BUILDING CODE OF AUSTRALIA CAPABILITY STATEMENT – Rev B
Property: New Diana Pet Food Factory/Warehouse at 91 Gardiner Street RUTHERFORD NSW

The purpose of this submission is to advise that we have undertaken a preliminary assessment of the architectural drawings SK0101, SK0102, SK1100, SK1101, SK1102, SK1105, SK2201, SK2203, SK2205, SK2501, SK3101 & SK4101, by Bell Architecture, Issue P1, dated 10 March 2022, submitted with the Development Application against the provisions of the NCC Volume 1 Building Code of Australia 2019 Amendment 1 (BCA) as per the requirements under Clause 19 of the Environmental Planning & Assessment (Development Certification and Fire Safety) Regulation 2021.

Figure 3 – 6 m Fire Brigade Vehicle Track

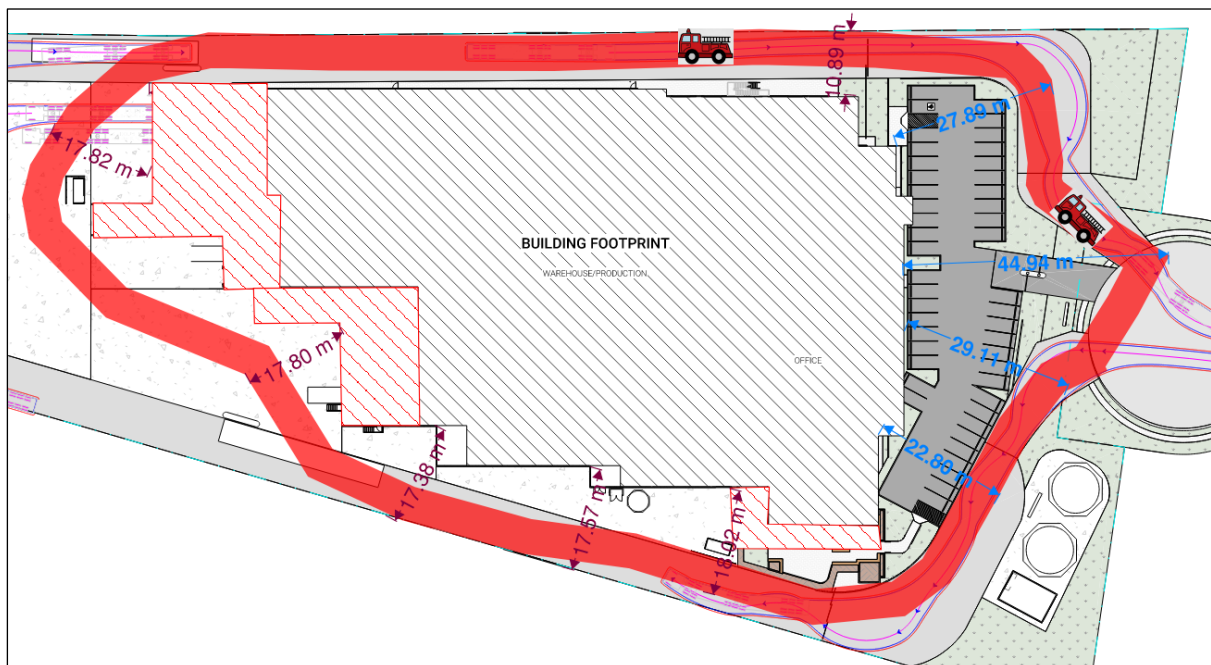
- a) Fire Brigade Vehicle Track - The eastern end of the track is not located within 18 m of the building, actual worse case 45 m, see Figure 3 below.
- b) Paths of Travel Widths – Local reductions at pinch points to not less than 800 mm, in lieu of 1 m, will be permitted to the warehouse, plant and production areas in general.

- a) The required 6 m track has been obstructed by the two Plate Weighbridges. These are required to be relocated away from the required track.
- b) The eastern end of the track is not located within 18 m of the building, actual worse case 45 m, see Figure 3 below. The hardstand carparking cannot technically be considered, because the fire track is supposed to be provided in a loop configuration that allows for forward travel at all times. The Fire Safety Engineer has confirmed the feasibility of a justifiable performance solution for inclusion within the FER. Report and consent from Fire and Rescue NSW will also be required.

Figure 4 – Stair 3 Discharge

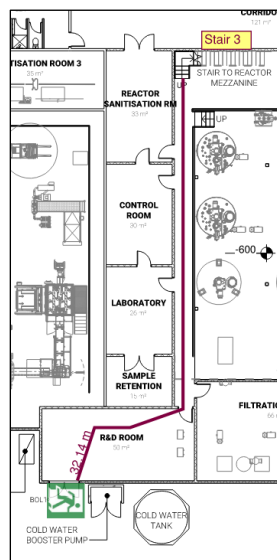
BCA Clause D1.9 specifies the provisions for non-fire isolated required stairs. Internal exit Stair 3 does not discharge within 20 m of an external exit door on Ground Level, nor within 40 m of an exit door on Ground Level where there is another exit door located at approximately opposite directions. It does however discharge within 33 m of the southern exit door at the R&D Room. The Fire Safety Engineer has confirmed the feasibility of a justifiable performance solution for inclusion within the FER.
